Document No. : DSSNK-2601-B0-1

Notification of Polarizer on LCD Panel to PFAS-free

Product Name: TCG058WXLBPVNN-AN30

* Photo shown: 12.1" panel.

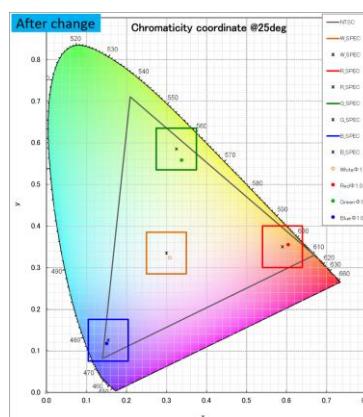
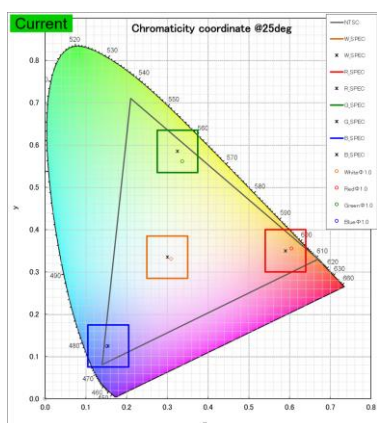
Item	Current	After change	Comment
AG (anti-glare) material	Contains PFAS	PFAS-free	Front polarizer
Appearance Difference			Same appearance as the current model.
